Map 1: Queens Parade precincts in Amendment C231

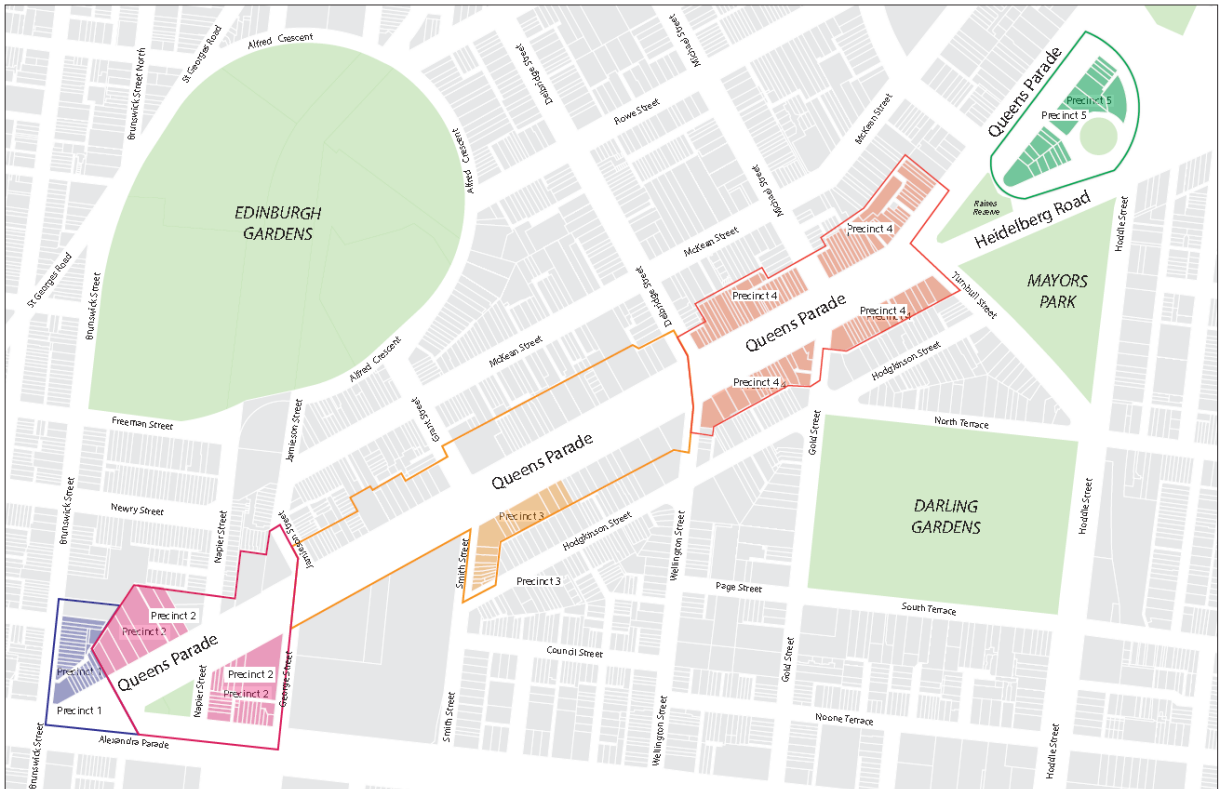
Precinct	Exhibited amendment	Description of recommended change
1		No substantive changes proposed
2A		No substantive changes proposed
2B	Includes NRZ land in NE corner of precinct. DDO does not apply to this land.	Deleted reference to this land and renamed precinct 2D to 2B.
2C	<p><u>Upper level setback</u> 5 metres (preferred)</p> <p><u>Street wall height</u> 18 metres (preferred)</p> <p><u>Side and rear setbacks</u> B17</p>	<p><u>Upper level setback</u> 6 metres (preferred)</p> <p><u>Street wall height</u> Reduced to 10 metres in Napier Street (mandatory) No other changes to street wall</p> <p><u>Side and rear setbacks</u> B17 to be replaced with building separation requirements (see below)</p> <p><u>Side setbacks (preferred)</u> Apply side setbacks above the street wall where windows are proposed.</p> <p>For habitable room windows, a 4.5m setback to the boundary applies. For a commercial or non-habitable room window, a 3m setback to the boundary applies.</p> <p><u>Rear setbacks (preferred)</u> At ground level, set back 4.5 metres from the centre of the lane.</p>

2D	<u>Rear setbacks</u>	<u>Rear setbacks</u>

None exhibited	Building to set back 4.5 metres from the centre of the lane (preferred).
3	<p><u>Height</u></p> <p>18 metres (5 storeys) (preferred)</p> <p><u>Street wall height (mandatory)</u></p> <p>11m at 15-33 Queens Parade</p> <p>14 metres elsewhere</p> <p><u>View to St John's (mandatory)</u></p> <p>View line from the centre of the footpath</p> <p><u>Rear setbacks (preferred)</u></p> <p>45° above 8 metres from rear boundary to a laneway</p> <p>45° above 5 metres from rear boundary (no laneway)</p>	<p><u>Height</u></p> <p>Reduced height of 14m (4 storeys) (mandatory) for heritage shops at 652-662 Smith Street. Created new precinct – precinct 3B.</p> <p>Height in precinct 3A remains at 18m but proposed to be mandatory.</p> <p><u>Street wall height (mandatory)</u></p> <p>11m at 15-33 Queens Parade</p> <p>35-37 Queens Parade – retain existing</p> <p>14 metres elsewhere in precinct 3A</p> <p>Retain height of existing heritage façade in precinct 3B</p> <p><u>View to St John's (mandatory)</u></p> <p>Viewpoint to St John's clarified and moved from footpath to pedestrian island at lights as intended in GJM report.</p> <p><u>Rear setbacks (preferred)</u></p> <p>Modified Standard B17 where there is a laneway</p> <p>3 metre setback at ground level then modified Standard B17 where there is no laneway</p> <p><u>Overshadowing (preferred)</u></p> <p>ResCode Standard limiting overshadowing of private open space to be applied</p>

4	<p><u>Height</u></p> <p>21.5 metres (6 storeys) mandatory</p> <p><u>Upper level setbacks (preferred and mandatory)</u></p> <p>6 metres, mandatory in significant streetscape area.</p> <p>Preferred elsewhere.</p> <p><u>Side and rear setbacks (preferred)</u></p> <p>45° above 8 metres from rear boundary to a laneway</p> <p>45° above 5 metres from rear boundary (no laneway)</p> <p><u>245 Gold Street</u></p> <p>Zoned Commercial 1 Zone, no rezoning proposed.</p>	<p><u>Height</u></p> <p>14 metres (4 storeys) mandatory</p> <p><u>Upper level setbacks (mandatory)</u></p> <p>8 metres, all mandatory.</p> <p>Removed reference to significant streetscape.</p> <p><u>Rear setbacks (preferred)</u></p> <p>Modified Standard B17 where there is a laneway</p> <p>3 metre setback at ground level then modified Standard B17 where there is no laneway</p> <p><u>245 Gold Street</u></p> <p>Rezone to Neighbourhood Residential Zone as requested by property owner.</p>

5A	<p><u>Height</u></p> <p>18 metres (preferred) (applies to the car park of the former UK Hotel only)</p> <p><u>Extent of UK Hotel land on DDO precinct 5 map</u></p>	<p><u>Height</u></p> <p>Reduced from 18m to 11m to match the height of the parapet or eaves of the former UK Hotel. Height now to be mandatory.</p> <p><u>Extent of UK Hotel land on DDO precinct 5 map</u></p>

Map incorrectly shows land at 2 Dummett Crescent in precinct 5B but should be in precinct 5A.	Map amended to include land at 2 Dummett Crescent in precinct 5A (precinct extended to match land ownership)
5B	<p><u>Height</u></p> <p>1:1 heritage street wall to new built form behind Clifton Motors and 203 Queens Parade, visible from the opposite side of Queens Parade (preferred)</p> <p>28m elsewhere (preferred)</p> <p><u>Street wall (mandatory)</u></p> <p>Match parapet height of former Clifton Motor Garage and eaves line of former UK Hotel</p> <p>11m elsewhere</p> <p>Upper level setback</p> <p>6m mandatory at Clifton Motors</p> <p>6m preferred elsewhere</p> <p><u>Side and rear setbacks</u></p> <p>0m</p>	<p><u>Height</u></p> <p>1:1 street wall requirement deleted but translated into building height</p> <p>201-215 Queens Parade – 18m (mandatory)</p> <p>28m preferred elsewhere (preferred)</p> <p><u>Street wall (mandatory)</u></p> <p>Street wall height now applies to all Queens Parade frontage in precinct 5B</p> <p>4-10 Dummett Cres – remains at 11m</p> <p><u>Upper level setback</u></p> <p>8m mandatory at Clifton Motors</p> <p>6m preferred elsewhere</p> <p><u>Side and rear setbacks</u></p> <p>Apply side setbacks above the street wall where windows are proposed:</p> <p>For habitable room windows, a 4.5m setback to the boundary applies.</p> <p>For a commercial or non-habitable room window, a 3m setback to the boundary applies.</p>

5C	<p><u>Street wall height</u></p> <p>36 metres</p> <p><u>Height</u></p> <p>49 metres (preferred)</p> <p><u>Upper level setback</u></p> <p>10 metres preferred</p> <p><u>Side and rear setbacks</u></p> <p>None proposed</p>	<p><u>Street wall height</u></p> <p>18 metres (reduced to provide a better relationship to the street and reduce wind impacts)</p> <p><u>Height</u></p> <p>43 metres preferred</p> <p><u>Upper level setback</u></p> <p>6 metres preferred</p> <p><u>Side and rear setbacks</u></p> <p>Apply side setbacks above the street wall where windows are proposed:</p> <p>For habitable room windows, a 4.5m setback to the boundary applies.</p> <p>For a commercial or non-habitable room window, a 3m setback to the boundary applies.</p>
